UNITED STATES PATENT AND TRADEMARK OFFICE

APPLICATION NO.	FILING DATE	FIRST NAMED INVENTOR	ATTORNEY DOCKET NO.	CONFIRMATION NO.
10/624,076	07/21/2003	Vladimir Mancevski	500929.000017B	5156

Office Action Summary	Application No. 10/624,076	Applicant(s) MANCEVSKI, VLADIMIR	
	Examiner DANIEL C. MCCracken	Art Unit 1793

DETAILED ACTION

FIG. 1B

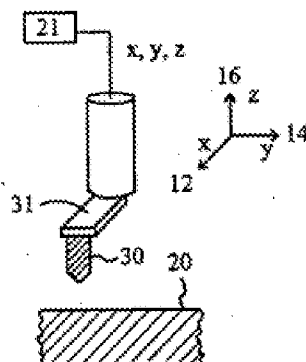
With respect to Claim 25, this claim requires “a substrate.” Baldeschwieler teaches a substrate. (Baldeschwieler “Fig. 1B,” 6: 9) (“cantilever 31”). Claim 25 further requires “at least one protrusion extending from the substrate.” Baldeschwieler teaches a protrusion. (Baldeschwieler “Fig. 1B,” 6: 10) (“tip 30”).

As to Claim 26, pointy tips are taught. (Baldeschwieler “Fig. 1B, Fig. 6”). As to Claim 27, a flat tip is taught. (Baldeschwieler “Fig. 6”) (note area between tip 42 and CNT 45). As to Claim 28, silicon is taught. (Baldeschwieler 6: 9-15). As to Claim 29, a tip/substrate of the same material is taught. *Id.* As to Claim 30, either Li or Crowley teaches the pore and catalyst configuration. (Li at 1703, “Fig. 4”), (Crowley 5: 52 *et seq.*, “Fig. 2-3”). As to Claim 31, at least iron is taught. *Id.* As to Claim 32, the perpendicular configuration is taught. *Id.* As to Claim 33, other angles are taught. (Li at 1703, “Fig. 4”). As to Claim 34, *see* (Baldeschwieler “Fig. 6”) (note area between tip 42 and CNT 45). As to Claim 35, the planar surfaces, ets are reasonably suggested by the embodiments in “Fig 1B” and “6” in Baldeschwieler. As to Claim 36, *see* (Li at 1703, “Fig. 4”), (Crowley 5: 52 *et seq.*, “Fig. 2-3”). As to Claim 37, the combination is reasonably suggested in light of the rationale expressed in connection with Claim 25 *supra*. As to Claim 38, the diameter is taught. *See e.g.* (Li at 1703, col. 1). As to Claim 39-40, SWNT (which would meet the limitations) are reasonably suggested by modification of growth conditions. (Li at 1703, col. 1) (“We believe that it is possible to produce arrays consisting of very thin and possibly even single-layered (4) carbon nanotubes, by improving the growth conditions.”). As to Claim 41, the aspect ratio is reasonably suggested by the figures of Li and Crowley. Alternatively, it is controlled by controlling the duration of the CVD reaction. As to Claim 42,
